Access Compliance Report

Public Rights-of-Way

| Intersection ID: 2576 | Main Street: CAMBRIDGE_BAY_DR | Cross Street: WHISTLER'S_CHASE_DR | Location: W |
| ADA ID: 99DB321618AD | Ramp Type: Perp | Initial Pass/Fail: Fail | Overall Compliance: No |

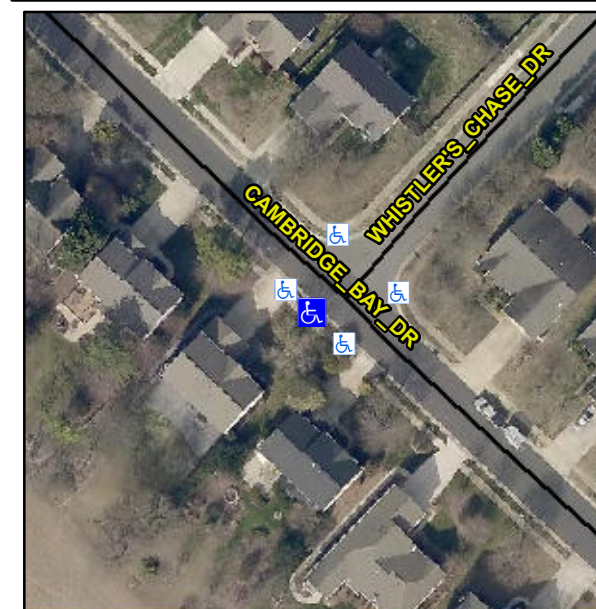
Not Found, R304.2.2, R304.5.3

| Compliance | Description | Data | Compliance | Description | Data |
|------------|-----------------------|-------|------------|-----------------------------|------|
| N/A | Ramp Length (in) | 46.5 | No | Ramp Slope (%) | 9.0 |
| Yes | Ramp Width (in) | 48.0 | No | Ramp XSlope (%) | 6.0 |

Remove & Replace Entire Ramp.
